(June 2019)	DEPAR'	TMENT OF THE I	NTERIOR				res: October 31, 2021		
		J OF LAND MAN				5. Lease Serial No.			
	SUNDRY NOT not use this form ndoned well. Use		to drill or to	re-enter an	,	6. If Indian, Allottee or	Tribe Name		
	SUBMIT IN TRIF	PLICATE - Other instru	uctions on page	e 2		7. If Unit of CA/Agree	ment, Name and/or No.

Update casing and cement program to current design.

Revised Permit Information 11/08/2023:

Well Name: Audacious 19 Fed Com 103H

1737' FSL Revised Wellbore A:

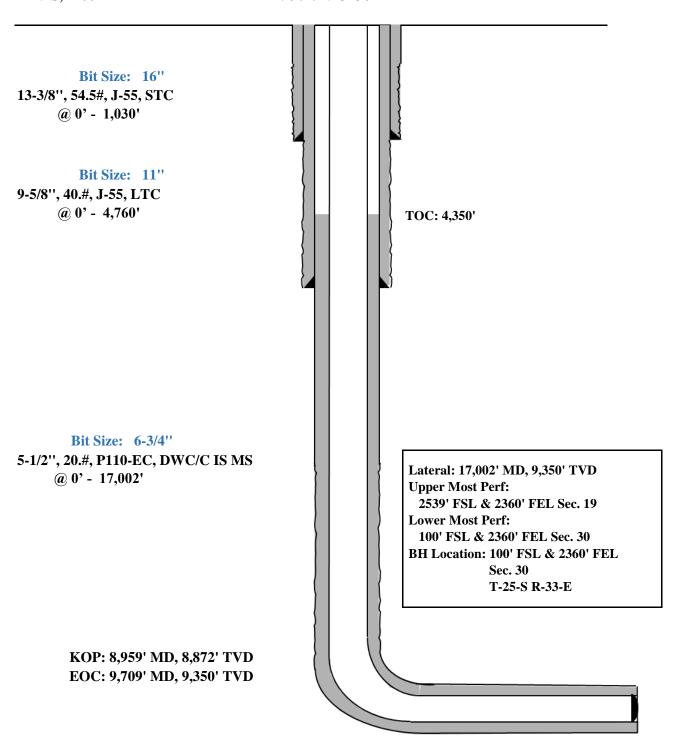
1. CASING PROGRAM A:

Hole	Interv	al MD	Interval TVD		Csg			
Size	From (ft)	To (ft)	From (ft)	To (ft)	OD	Weight	Grade	Conn
16"	0	1,030	0	1,030	13-3/8"	54.5#	J-55	STC
11"	0	4,845	0	4,760	9-5/8"	40#	J-55	LTC
6-3/4"	0	17,002	0	9,350	5-1/2"	20#	P110-EC	DWC/C IS MS

Variance is requested to waive the centralizer requirements for the 9-5/8" casing in the 11" hole size. An expansion additive will be utilized, in the cement slurry, for the entire length of the 11" hole interval to maximize cement bond and zonal isolation.

Variance is also requested to waive any centralizer requirements for the 5-1/2" casing in the 6-3/4" hole size. An expansion additive will be utilized, in the cement slurry, for the entire length of the 6-3/4" hole interval to maximize cement bond and zonal isolation.

EOG requests permission to allow deviation from the 0.422" annulus clearance requirement for the intermediate (salt) section from Onshore Order #2 under the following conditions:

1737' Revised Wellbore B: KB: 3476'
2367' GL: 3451'

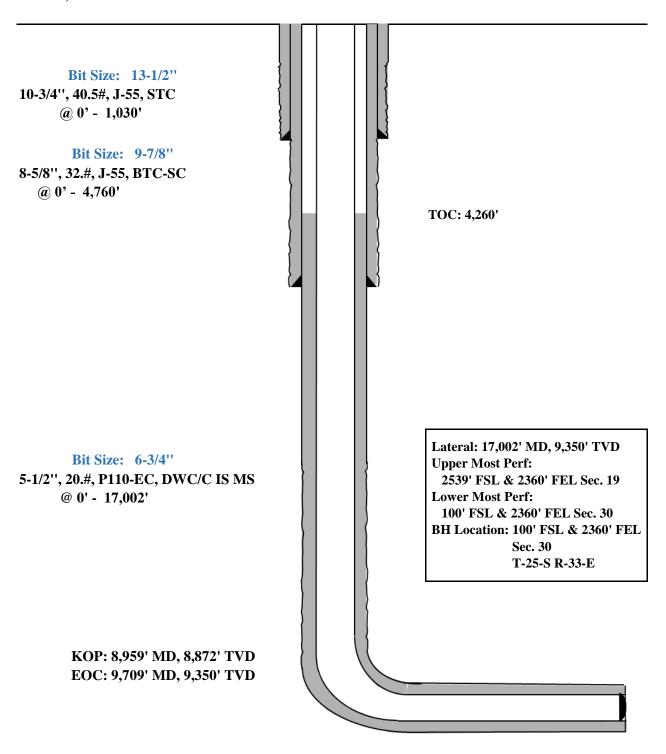
1. CASING PROGRAM B:

Hole	Interval MD		Interval TVD		Csg			
Size	From (ft)	To (ft)	From (ft)	To (ft)	OD	Weight	Grade	Conn
13-1/2"	0	1,030	0	1,030	10-3/4"	40.5#	J-55	STC
9-7/8"	0	4,845	0	4,760	8-5/8"	32#	J-55	BTC-SC
6-3/4"	0	17,002	0	9,350	5-1/2"	20#	P110-EC	DWC/C IS MS

Variance is requested to waive the centralizer requirements for the 8-5/8" casing in the 9-7/8" hole size. An expansion additive will be utilized, in the cement slurry, for the entire length of the 9-7/8" hole interval to maximize cement bond and zonal isolation.

Variance is also requested to waive any centralizer requirements for the 5-1/2" casing in the 6-3/4" hole size. An expansion additive will be utilized, in the cement slurry, for the entire length of the 6-3/4" hole interval to maximize cement bond and zonal isolation.

EOG requests permission to allow deviation from the 0.422" annulus clearance requirement for the intermediate (salt) section from Onshore Order #2 under the following conditions:
